Maule Aircraft Corporation

SERVICE LETTER #38

SUBJECT: Possible float plane reinforcement deficiency.

MODELS AFFECTED: M-5-235C, S/N 7073C thru 7077C, 7079C, and 7085C.

REINFORCEMENT INSTALLATION INSTRUCTIONS

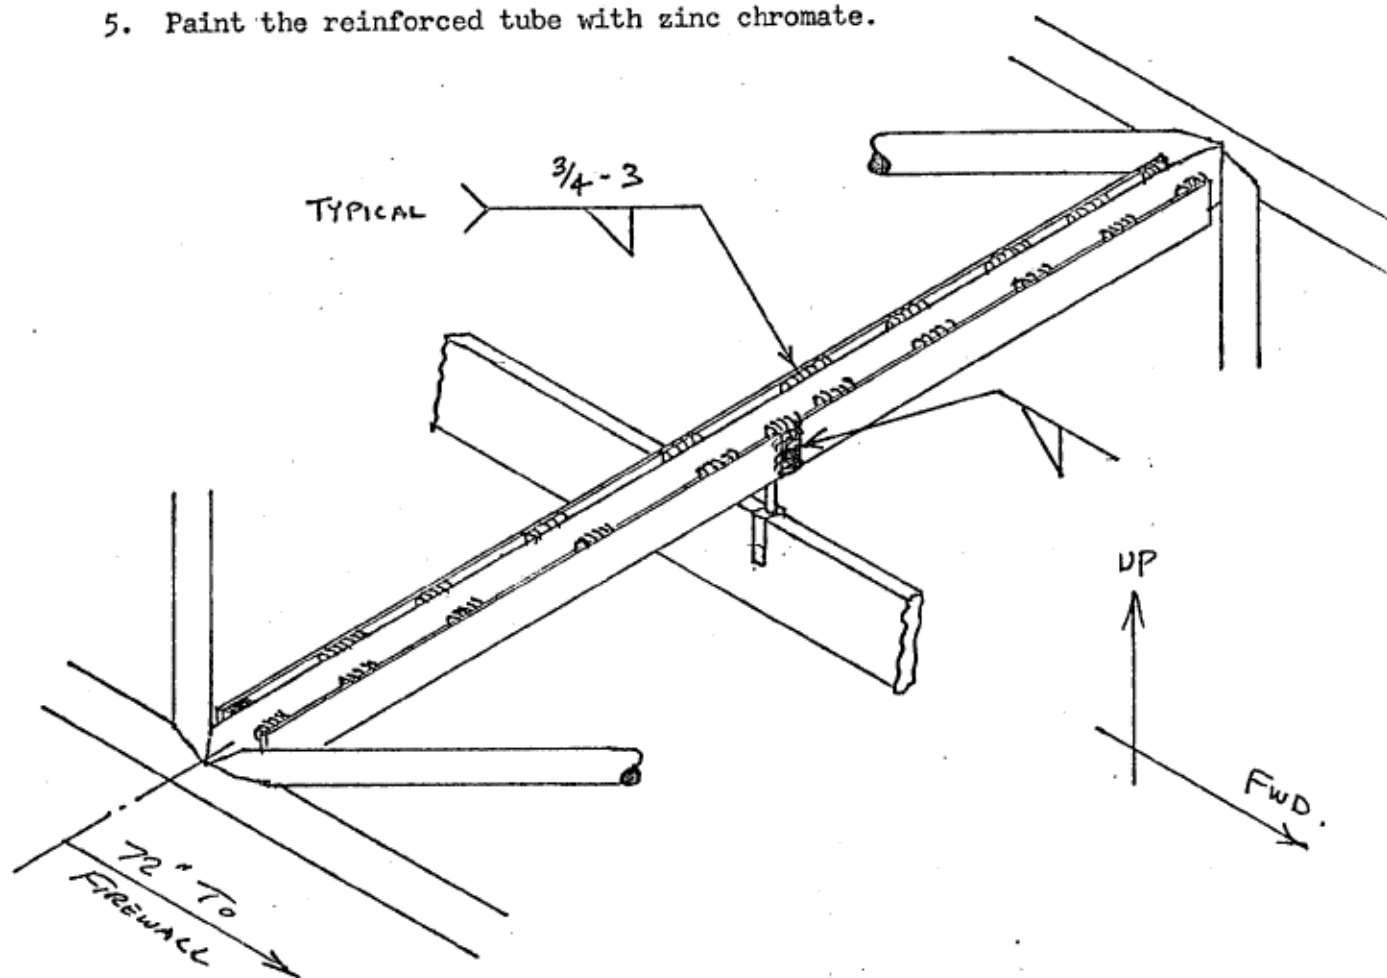
BACKGROUND: There is a possibility that tube #127 (Fuselage bottom, transverse, at the rear/cargo door junction) was not reinforced when the float plane reinforcement kit was installed on these airplanes.

If the tube is 3/4 inch in diameter, the float plane reinforcement was not installed on this tube. If you now have the aircraft mounted on floats, you must install this reinforcement before you fly it again.

1. Slide reinforcing tube into fuselage belly below and behind tube to be reinforced, with the channel opening up and the slot forward.
2. Align the slot in the reinforcement with the fabric Stand-off tube and slide the reinforcement up around tube #127, still with the channel opening up.
3. Clamp the reinforcement to the tube and weld both sides of the channel, at the top, to the tube, using a $3/4$ inch fillet weld every three inches.

CAUTION: Spread wet cloths over the fabric in the area being welded, and have a fire extinguisher handy.

4. Weld slot closed.
5. Paint the reinforced tube with zinc chromate.
